Addendum No. 07

July 27, 2026

Parlier HS Stadium Replacement

PBK PROJECT NO.: 250093
DSA FILE NO.: 10-H12
DSA APPLICATION NO.: 02-124002 _ PARLIER HS STADIUM REPLACEMENT

A IRRIGATION YARD - IRRIGATION PLAN ENLARGEMENT
1" = 6'-0"

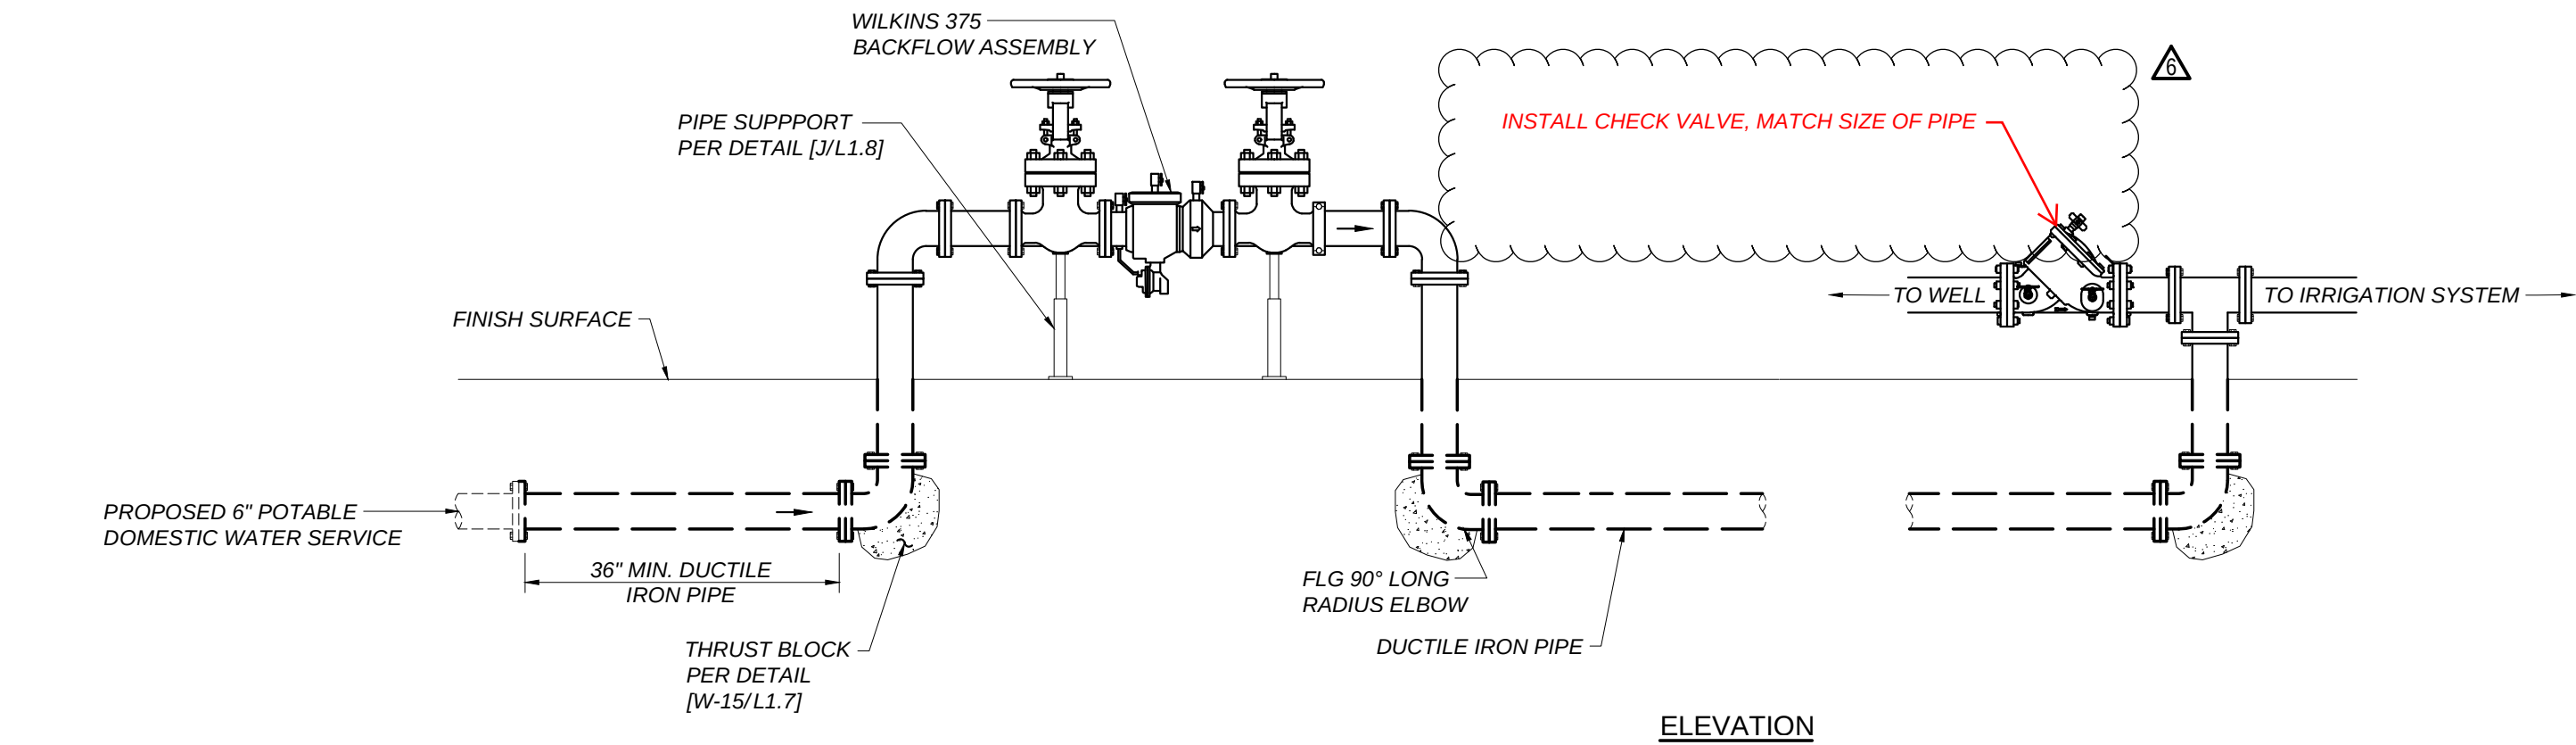
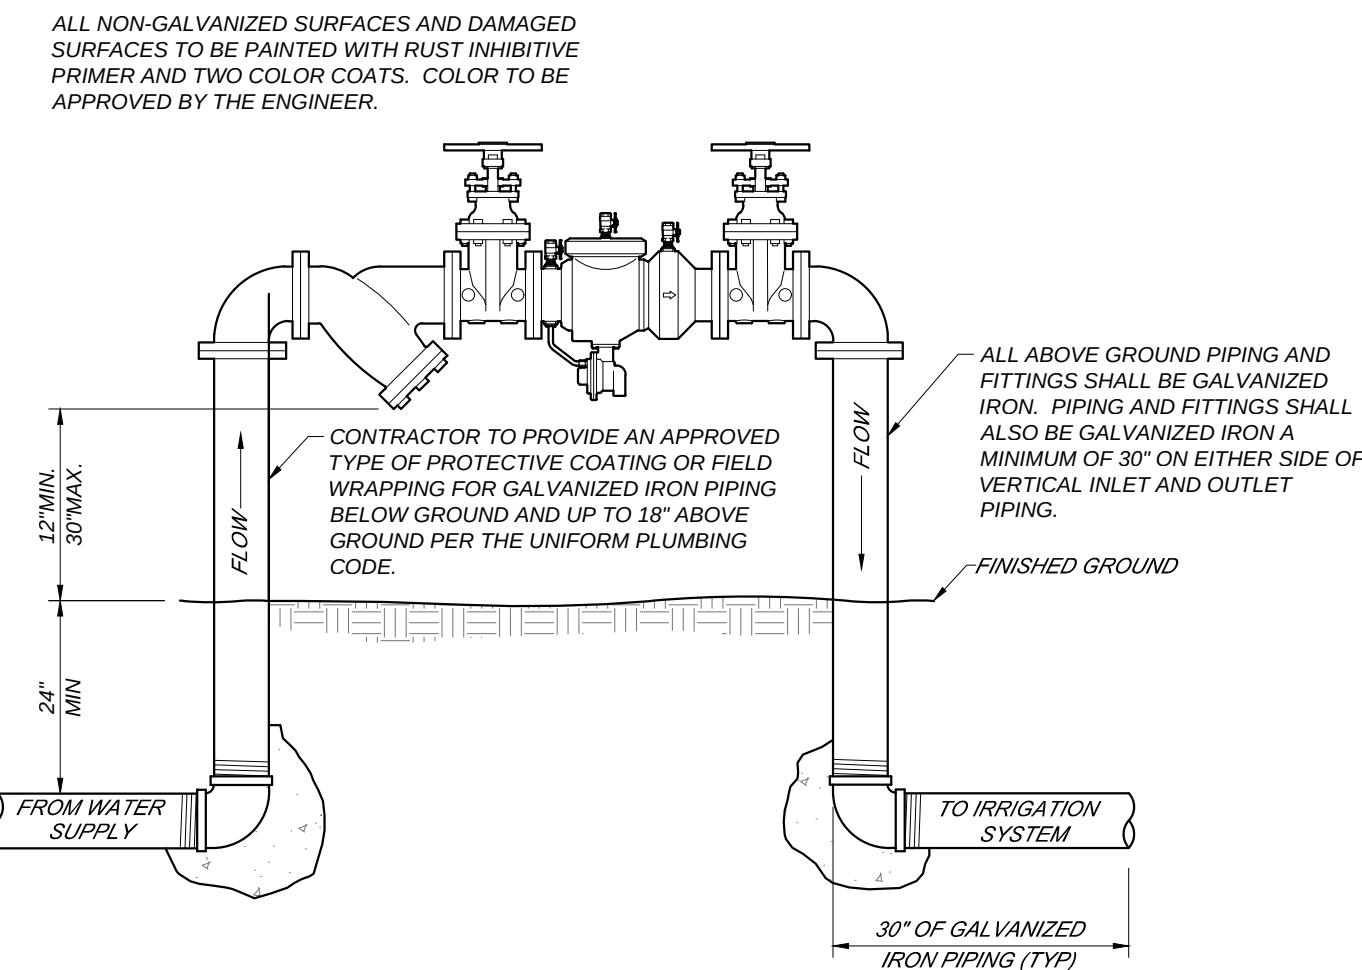
- 1. Refer to sheet LS1.6 "IRRIGATION DETAIL"
 - a. Remove and replace sheet LS1.6 "IRRIGATION DETAIL" with herein attached sheet LS1.6 "IRRIGATION DETAIL" identified with AD7 on the bottom right-hand corner.
